The Price Display – Case Design Changes – Back panel only.

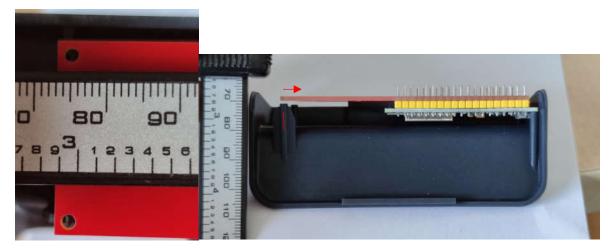
1. The rear legs need to move in by 0.5mm

2. Increase top height of rear legs by 0.7mm

3. Make rear screw holes a little deeper (so screw can go down further).

4. The holes for the inner centre point and size incorrect.

The computer chip (black board) holes were bigger than the 3D design provided. The holes are 2.6mm in diameter, and the centre point is 2mm in from the corner. This caused the inner screw holes to not line up correctly.
